Docket Item # 6 & 7
BAR CASE # 2009-0309 & BAR
CASE # 2010-0002

BAR Meeting
January 20, 2010

ISSUE: Addition, Alterations and Waiver of Rooftop HVAC Screening Requirement

LOCATION: 206 Duke Street

Figure 4. East elevation – existing and proposed.

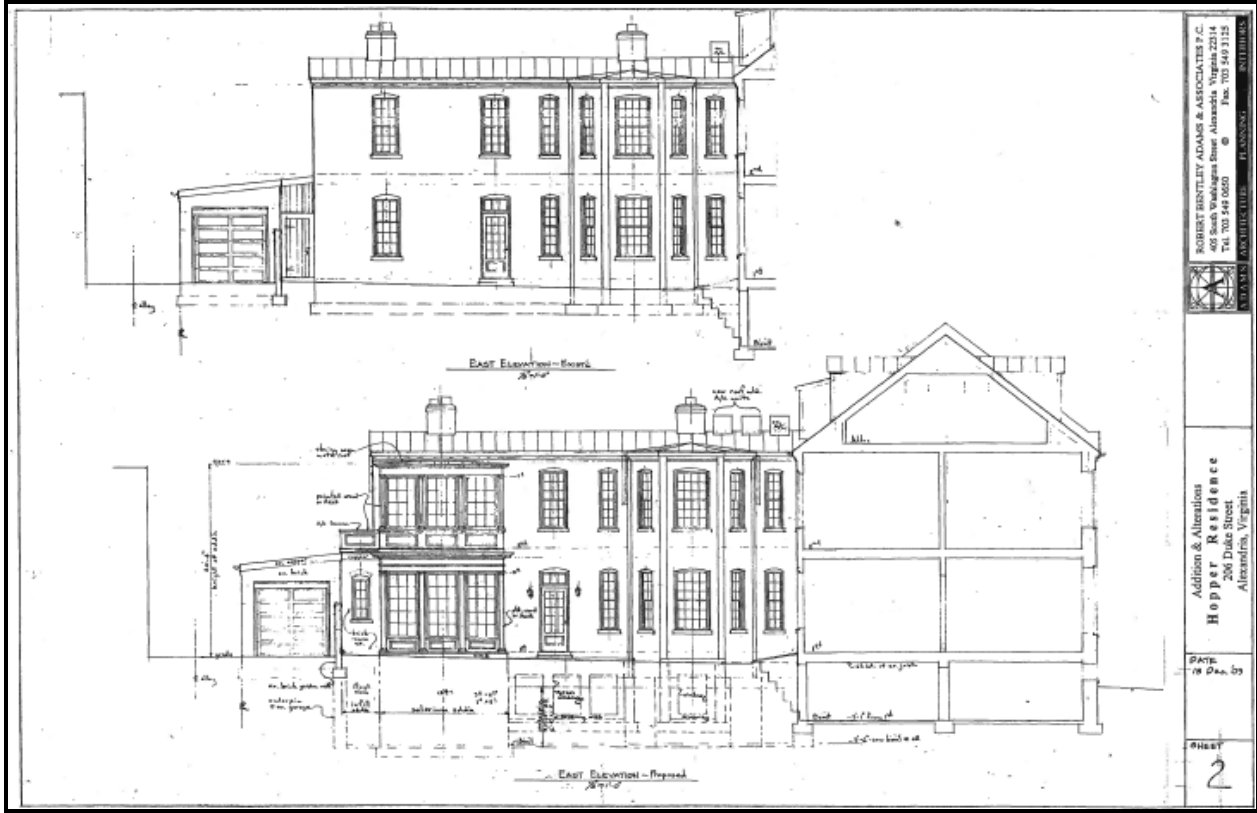
The proposed addition will have a two story component and a one story infill component. The two-story portion will project off of the east elevation of the ell and will measure 14 feet wide by 7 feet long and will have a height of 20 feet 4 inches. The east elevation will contain three multi-light windows on both the first and second floors, separated by pilasters. There will be a trim panel under each window. On the south elevation there will be two multi-light windows on the second floor. There will be a panel below the easternmost window; while below the other window there will be a paneled enclosure to screen the rooftop HVAC unit on the roof of the one story portion of the addition. The north elevation of the addition will contain two multi-light windows on each story, with a larger single panel below each window. The applicant has specified that the trim on the addition, including the pilasters and the trim panels, will be constructed of either Azek or wood. The low sloped roof of the addition will be clad with standing seam copper.

1. That the synthetic trim be solid-through-the-core and paintable;
2. That the applicant meet the five foot side yard setback on the east property line for the proposed HVAC condenser unit or obtain a waiver of this requirement from the adjacent property owner at 202 Duke Street; and
